Access Compliance Report
Public Rights-of-Way
(Curb Ramps)

Intersection ID: 48262	**Main Street:** EAST_ARBORS_DR	**Cross Street:** CLAUDE_FREEMAN_DR	**Location:** E
ADA ID: 91EBC7977293	**Ramp Type:** Perp	**Initial Pass/Fail:** Fail **Overall Compliance:** No	**Severity Score:** 25

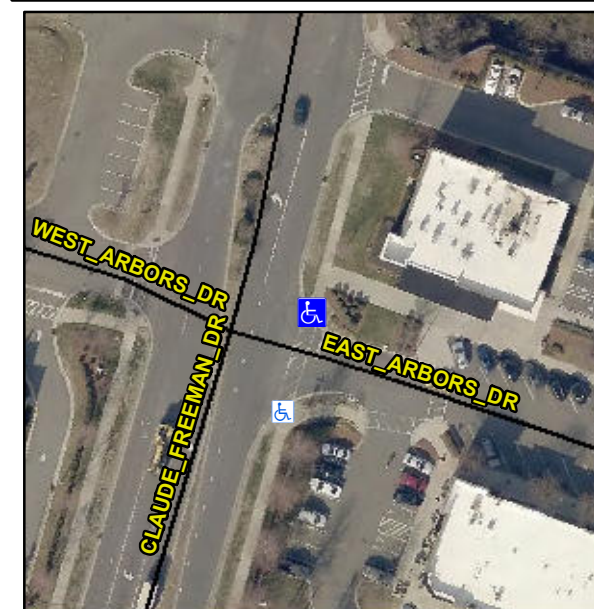
R304.2.2, R304.5.3

Compliance	Description	Data	Compliance	Description	Data
N/A	Ramp Length (in)	49.5	No	Ramp Slope (%)	10.2
Yes	Ramp Width (in)	54.0	No	Ramp XSlope (%)	6.5
N/A	Flare Type LT	N/A	N/A	Flare Type RT	N/A
N/A	Flare Slope LT (%)	N/A	N/A	Flare Slope RT (%)	N/A
N/A	Flare Traversable LT?	N/A	N/A	Flare Traversable RT?	N/A
N/A	Landing Length (in)	N/A	N/A	DWS Provided?	N/A
N/A	Landing Width (in)	N/A	N/A	DWS Contrast?	N/A
N/A	Landing Slope (%)	N/A	N/A	DWS Length (in)	N/A
N/A	Landing X Slope (%)	N/A	N/A	DWS Full Width?	N/A
N/A	Landing Curb? (Y/N)	N/A	N/A	DWS Offset (in)	N/A
N/A	Shared Landing?	N/A			
N/A	Gutter Ponding?	N/A	N/A	Gutter Slope (%)	N/A
N/A	Gutter Lip Ht (in)	N/A	N/A	Gutter X Slope (%)	N/A
N/A	Painted X Walk1?	Yes	N/A	Painted X Walk2?	N/A
	X Walk 1 Direction	To SW		X Walk 2 Direction	N/A
N/A	X Walk 1 Width (in)	89.0	N/A	X Walk 2 Width (in)	N/A
	X Walk 1 Slope (%)	4.5		X Walk 2 Slope (%)	N/A
	X Walk 1 X Slope (%)	0.3		X Walk 2 X Slope (%)	N/A

Remove & Replace Entire Ramp.
